**PLANNING COMMISSION
Regular Meeting
Monday, January 14, 2019
6:00 PM
Christine Nuernberg Hall**

Agenda

TO: Planning Commission
FROM: BRIDGET HENK, ASSISTANT CITY ENGINEER
DATE: January 14, 2019
SUBJECT: P2 Development for RKC Limited Partnership. The applicant is seeking fill permit approval to excavate the foundation at 11124 N. Industrial Drive and to fill the lots at 11127 and 11050 N. Industrial Drive and 6209 W. Mequon Road (Foxtown Development).

TO: Planning Commission
FROM: BRIDGET HENK, ASSISTANT CITY ENGINEER
DATE: January 14, 2019
SUBJECT: Stantec for Bill Arpe. The applicant is seeking fill permit approval for landscape pond extension (5.6. acres) and fill of cut areas (20 acres) for the property located at 4550 W. Highland Road.

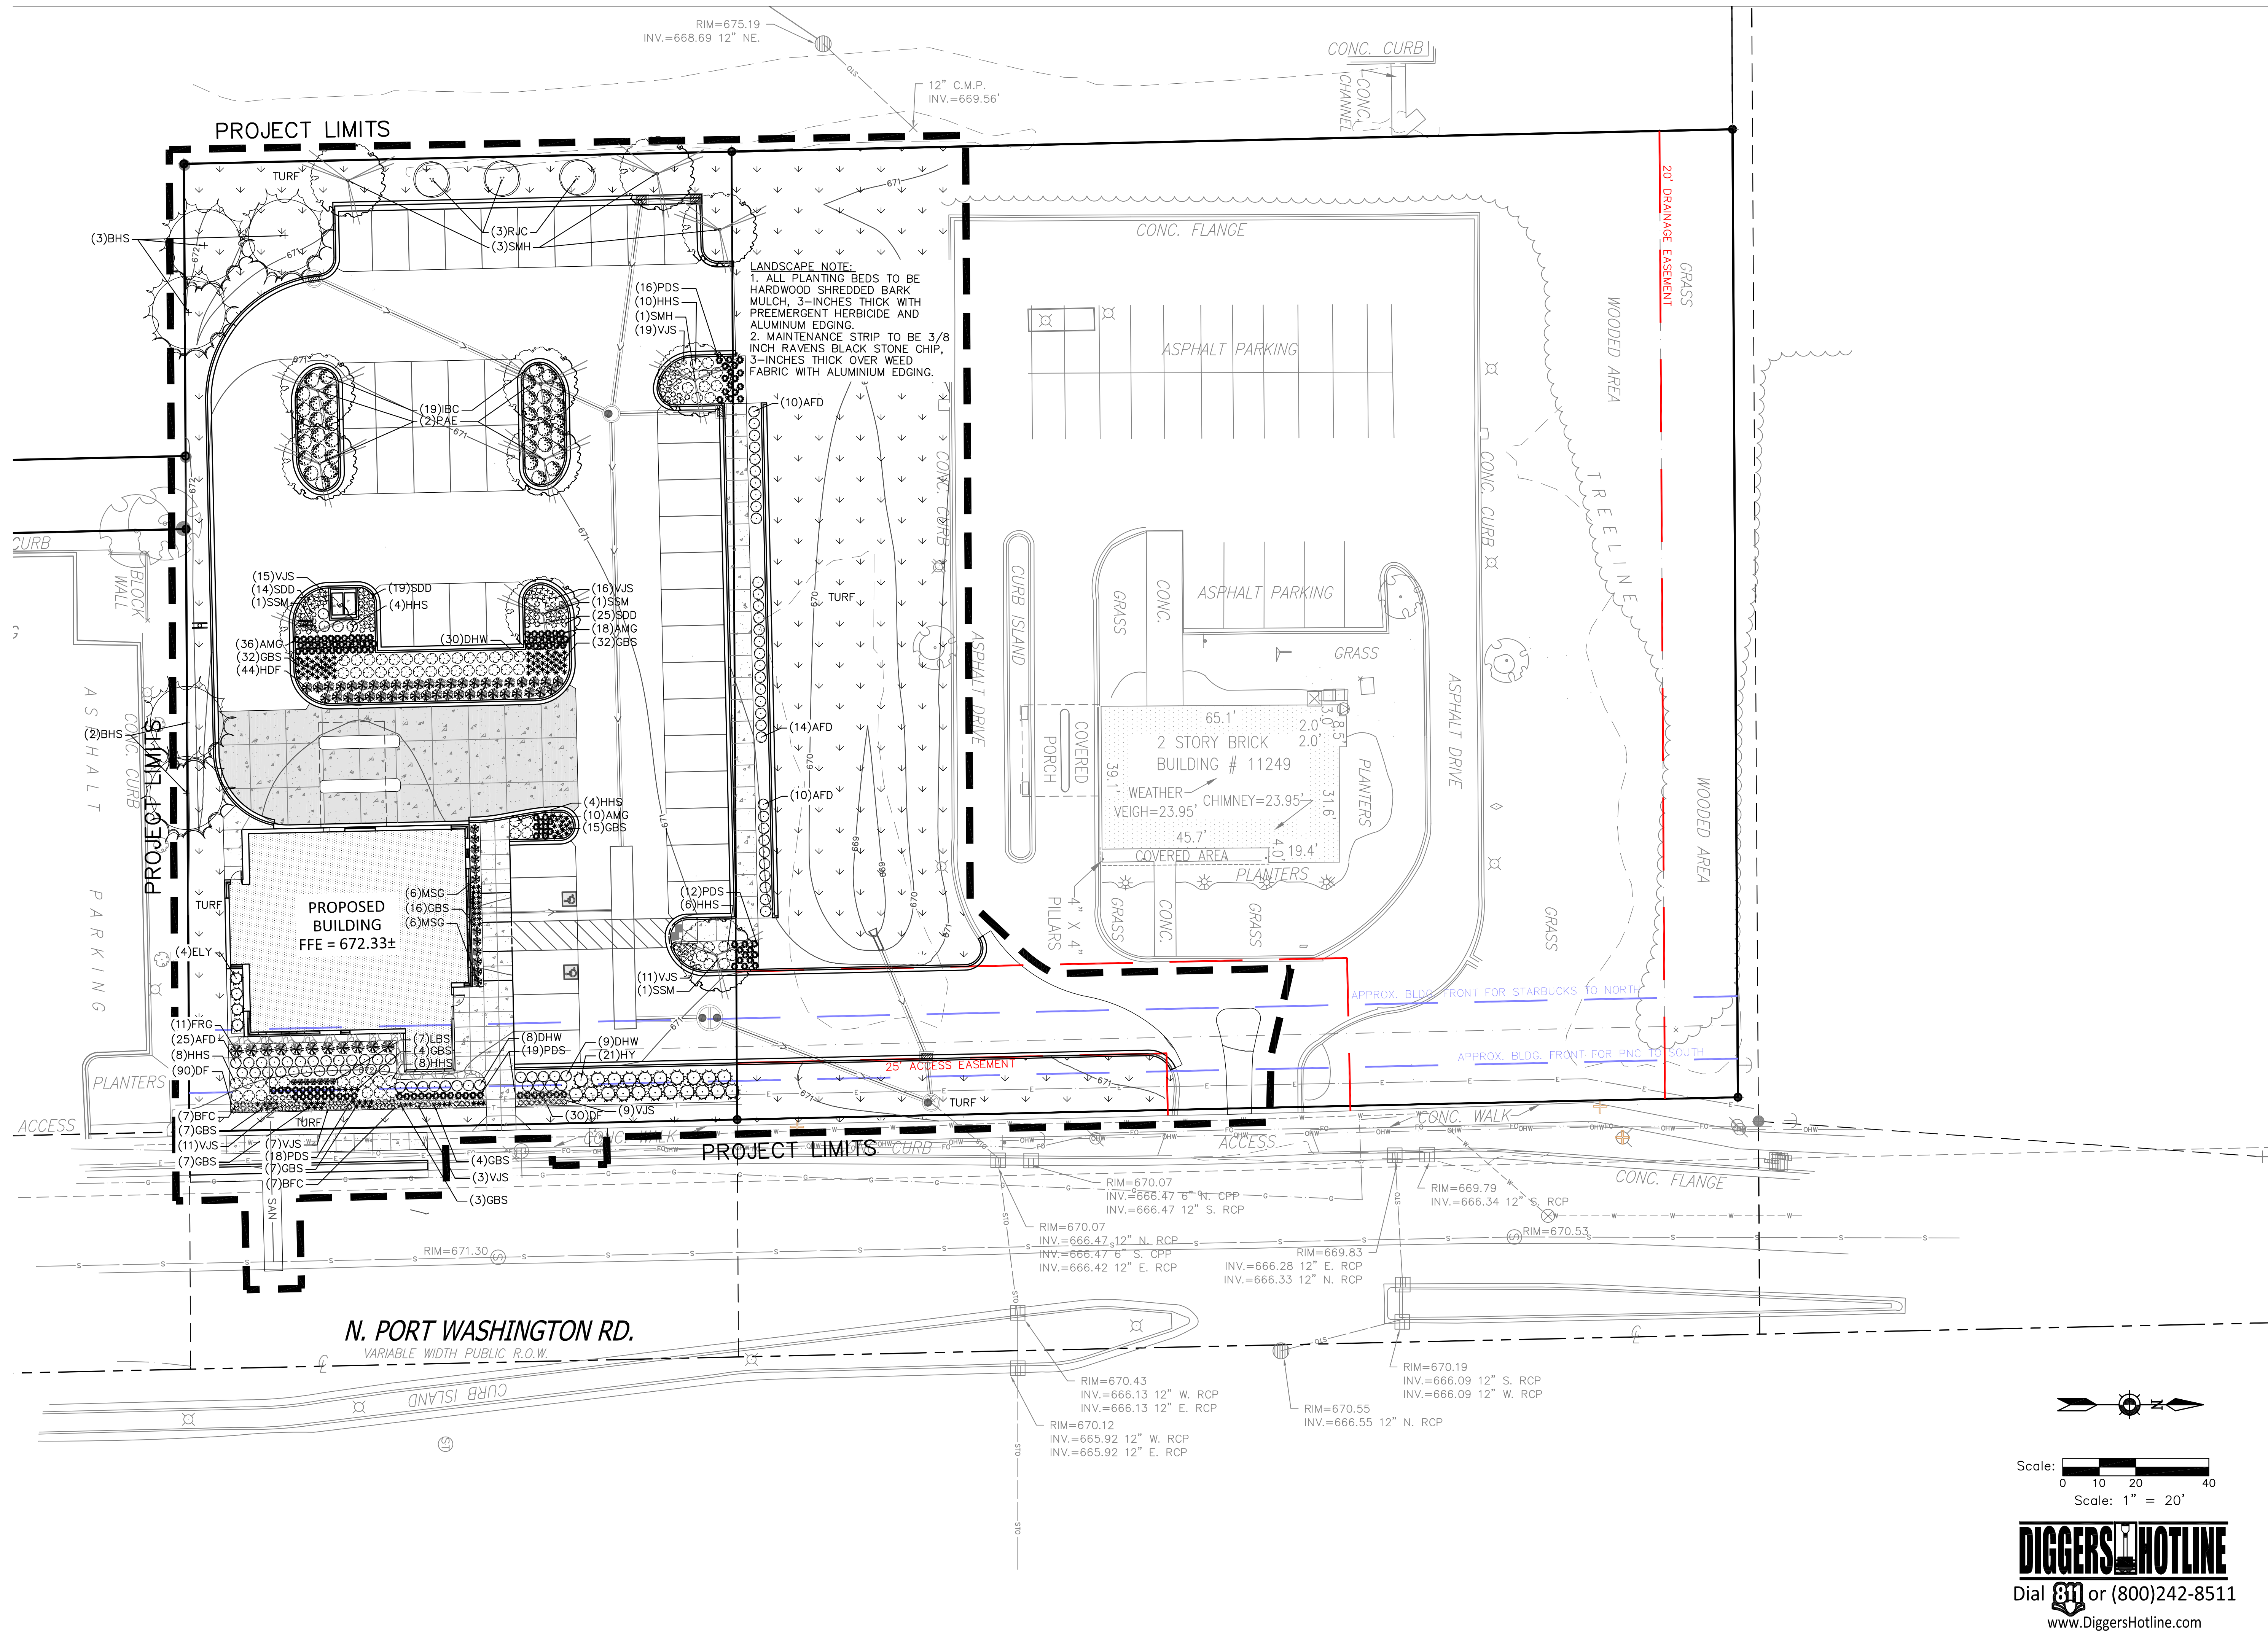
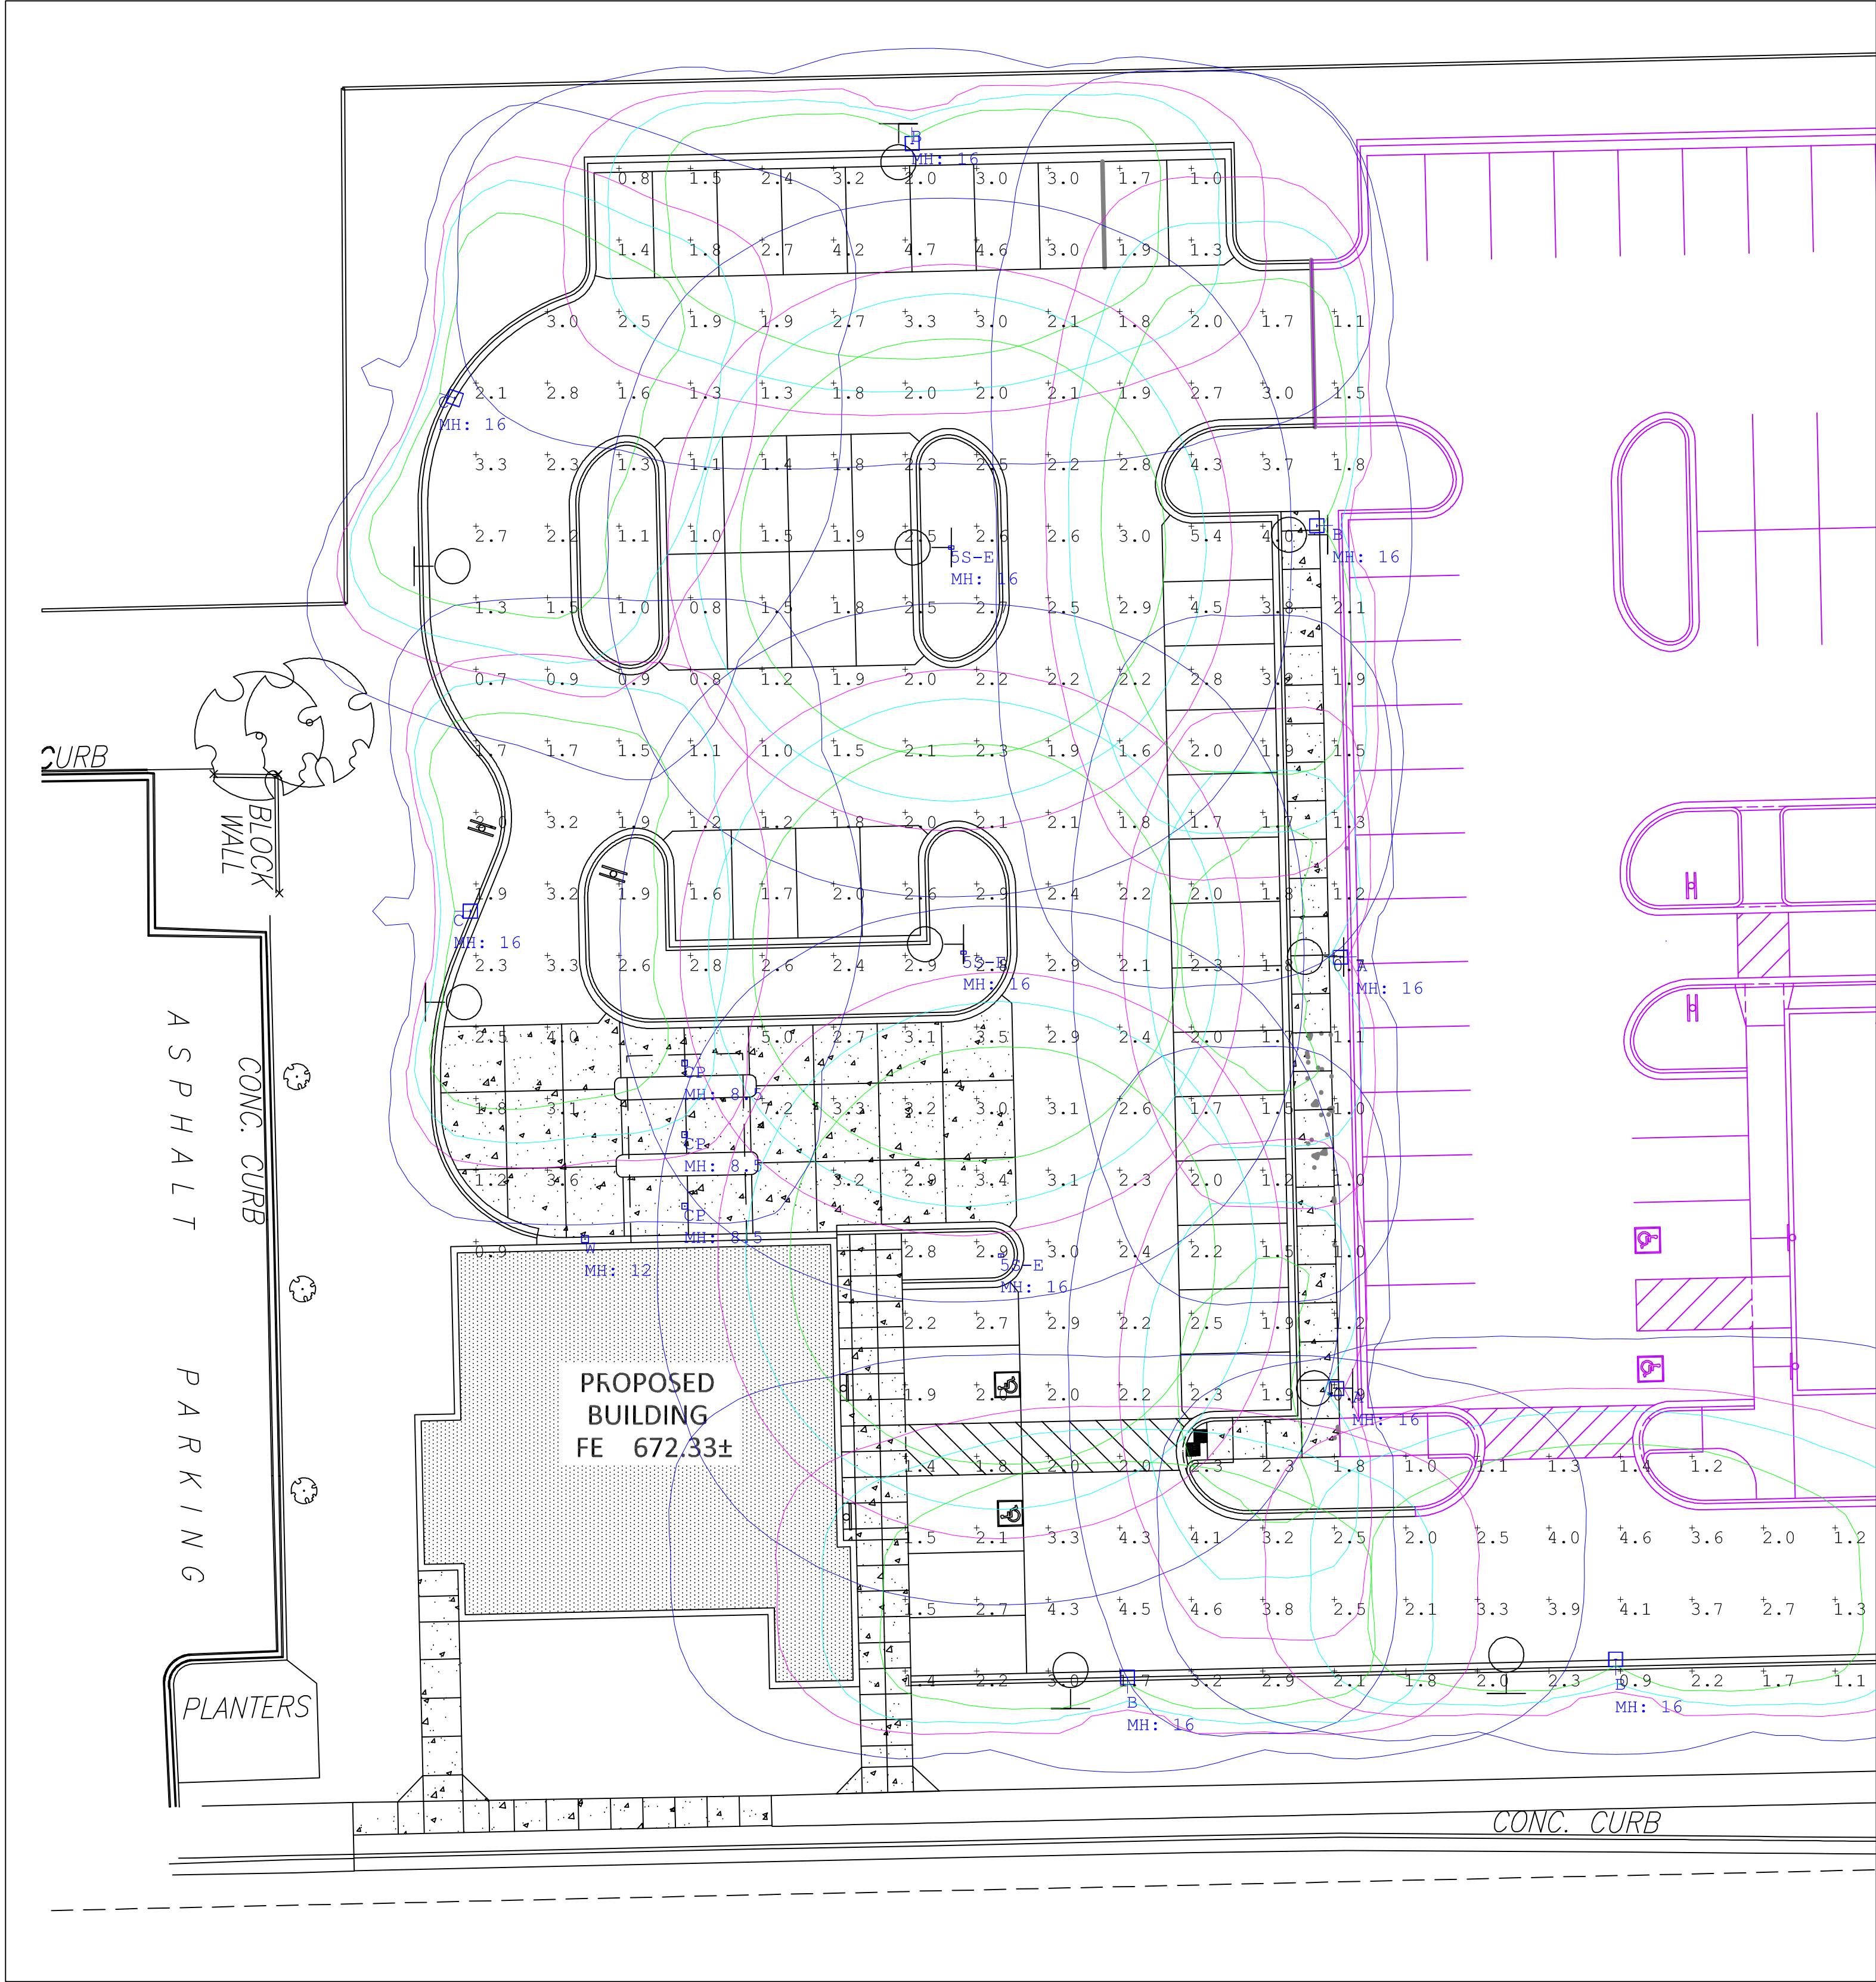
- ❖ This review pertains to Landscape Plan sheets L101 & L102, both sheets Dated 8/03/2018, LANDSCAPE PLAN
- ❖ The plan **is not currently** sealed by a Wisconsin RLA, **as required by Mequon code**. Final plan shall be sealed and submitted to City Staff.
- ❖ The plan is issued at a 1"=20' scale; the plan sheet is clean and the information is somewhat discernible.
 - The Proposal is adjacent to the Port Washington Road Corridor; the proposed commercial site use has one ingress/egresses onto a 120' frontage drive. PWR is one of Mequon's regional collectors and part of the City of Mequon's designated "Gateway" roadways. Since 2012, the P&Z board has requested additional density landscape treatments and larger scale plantings, especially adjacent to the PWR
